SUNDRY NOTICES AND REPORTS ON WELLS

Bolack B LS #2

Bolack B LS #2
PXA Procedures

CONDITIONS OF APPROVAL

BOLACK B LS 002
LOCATION - 12 - 27N - 8W
SINGLE FT
ORIG.COMPLETION - 5/92 TO FT
LAST FILE UPDATE - 8/93 BY CSW

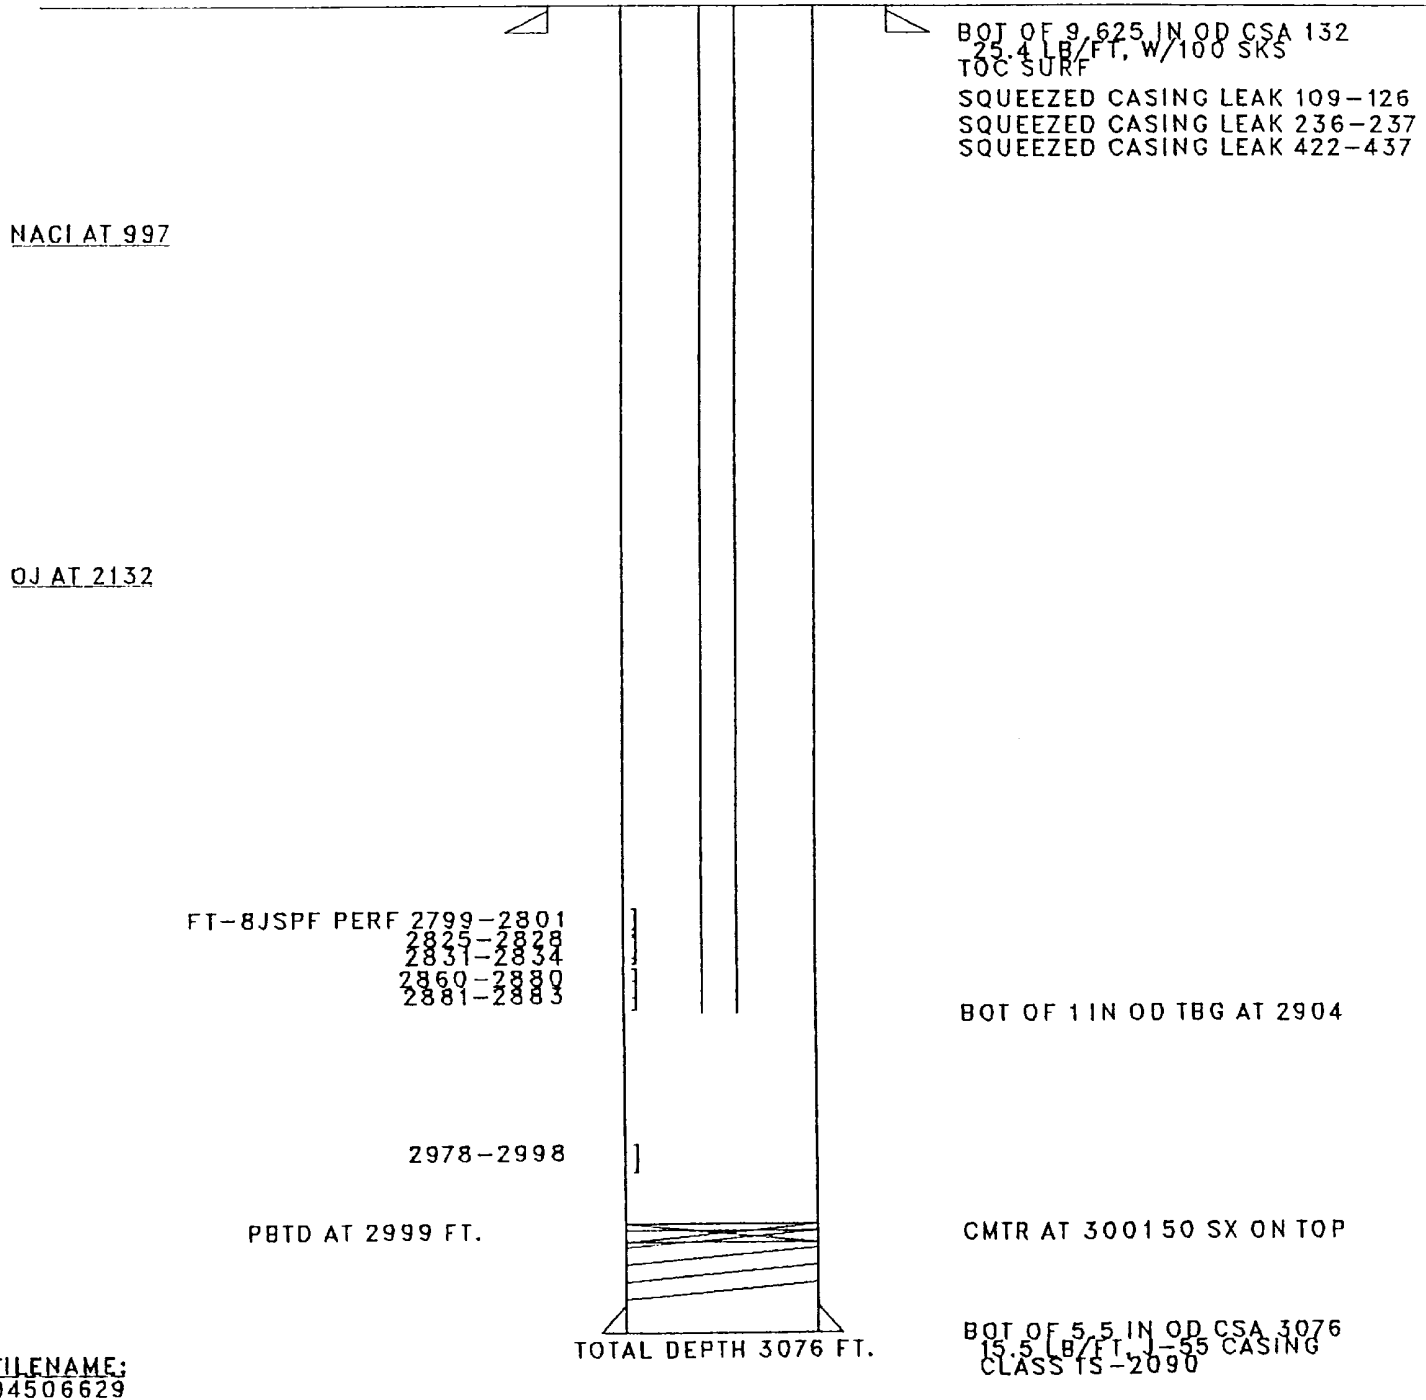
- 1.) Extend cement plug from 2750' (Top of retaining) to 2082' (50' above Top of Ojo Alamo @ 2132')
- 2.) Adjust cement volume placed behind the casing @ 1047' to fill 100' plus 100% excess.
(5 1/2" cas - 7 7/8" hole - @ 35 ft³)
- 3.) Perforate @ 182' and circulate cement to the surface. (50' below surface cas. @ 132')
